# Access Compliance Report

## Public Rights-of-Way

### (Curb Ramps)

Intersection ID: 11659	Main Street: E_16TH_ST	Cross Street: N_DAVIDSON_ST	Location: S
ADA ID: 353187BB78BF	Ramp Type: PerpDiag	Initial Pass/Fail: Fail	Overall Compliance: No
		Severity Score: 12.5

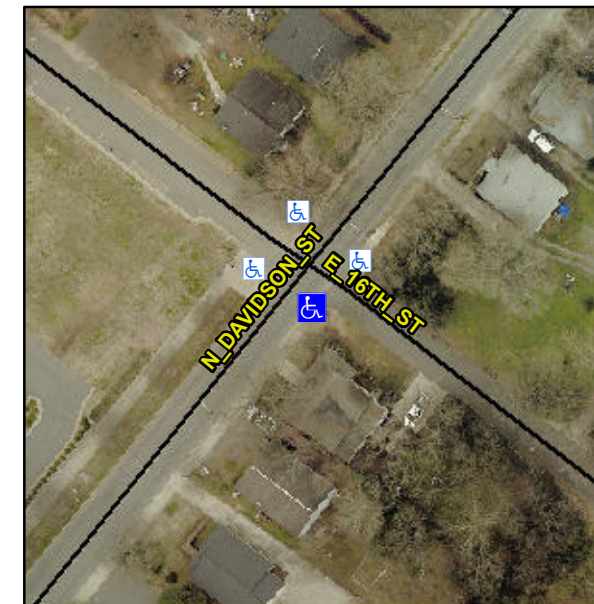
**Not Found, R304.2.2**

Compliance	Description	Data	Compliance	Description	Data
N/A	Ramp Length (in)	56.0	No	Ramp Slope (%)	8.5
Yes	Ramp Width (in)	55.0	Yes	Ramp XSlope (%)	0.8
N/A	Flare Type LT	N/A	N/A	Flare Type RT	N/A
N/A	Flare Slope LT (%)	N/A	N/A	Flare Slope RT (%)	N/A
N/A	Flare Traversable LT?	N/A	N/A	Flare Traversable RT?	N/A
N/A	Landing Length (in)	N/A	N/A	DWS Provided?	N/A
N/A	Landing Width (in)	N/A	N/A	DWS Contrast?	N/A
N/A	Landing Slope (%)	N/A	N/A	DWS Length (in)	N/A
N/A	Landing X Slope (%)	N/A	N/A	DWS Full Width?	N/A
N/A	Landing Curb? (Y/N)	N/A	N/A	DWS Offset (in)	N/A
N/A	Shared Landing?	N/A			
N/A	Gutter Ponding?	N/A	N/A	Gutter Slope (%)	N/A
N/A	Gutter Lip Ht (in)	0.5	N/A	Gutter X Slope (%)	N/A
N/A	Painted X Walk1?	No	N/A	Painted X Walk2?	No
	X Walk 1 Direction	To NE		X Walk 2 Direction	To NW
N/A	X Walk 1 Width (in)	N/A	N/A	X Walk 2 Width (in)	N/A
	X Walk 1 Slope (%)	1.0		X Walk 2 Slope (%)	0.2
	X Walk 1 X Slope (%)	2.3		X Walk 2 X Slope (%)	3.3

**Remove & Replace Curb Ramp With Two New Directional Ramps or Equivalent.**
